Great Scott Cape

First Floor Plan

Artform Home Plans AFHP Design # 410-123-v2 KR © 2012-2014 Wendy Nelson 603.431.9559		Great Scott Cape 15 Lorden Commons Londonderry, NH	
1/4"=1'-0" unless noted otherwise / Print at 1:1 PDF created on: 3/12/2014, 11:00 AM by ACJ		1 Based on: Construction	
R2: 3.12.2014 - Minor interior changes

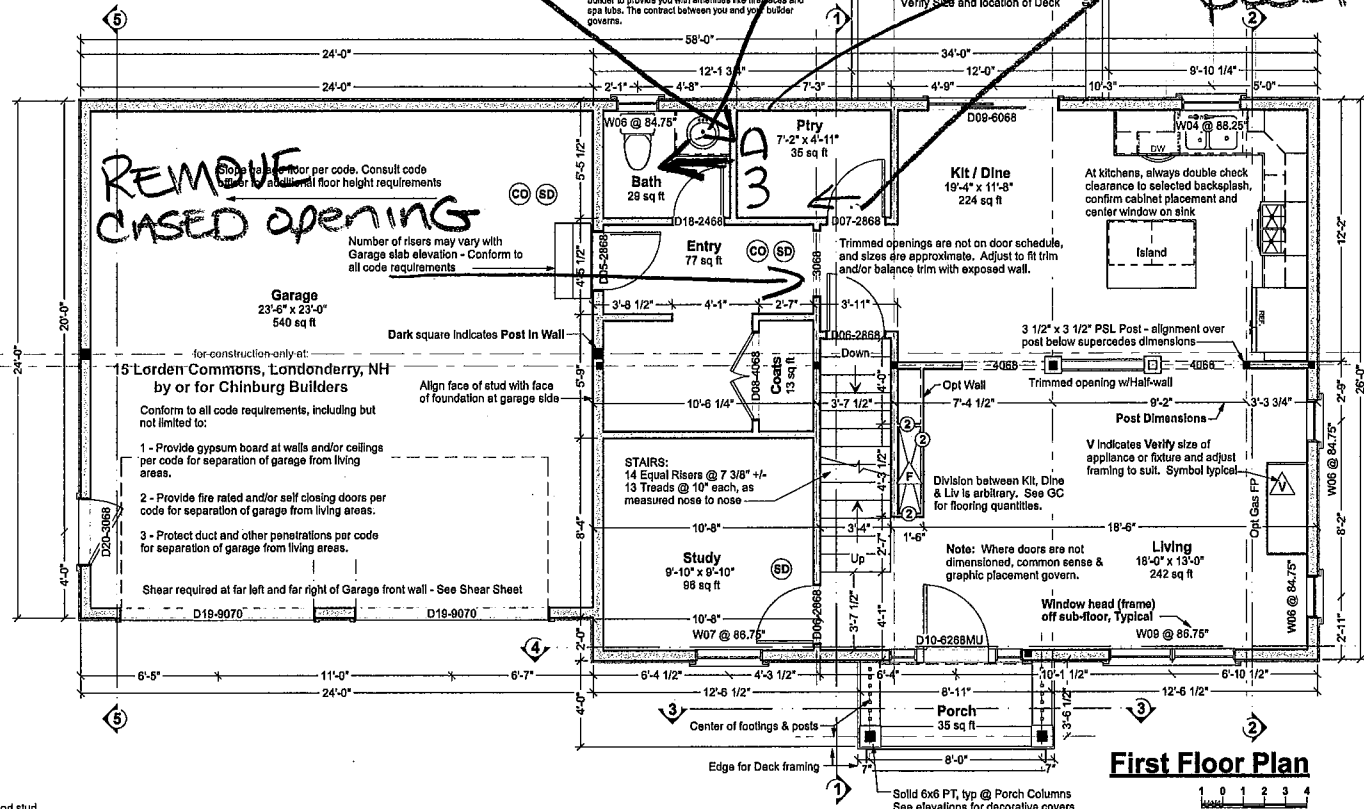
MOVE WALL 6" TO LEFT

PEDASTAL
SINK

1. ADD WASHER / DRYER
2. POCKET DOOR

move TO
LEFT as
far as
possible

REMOVE
CASED opening
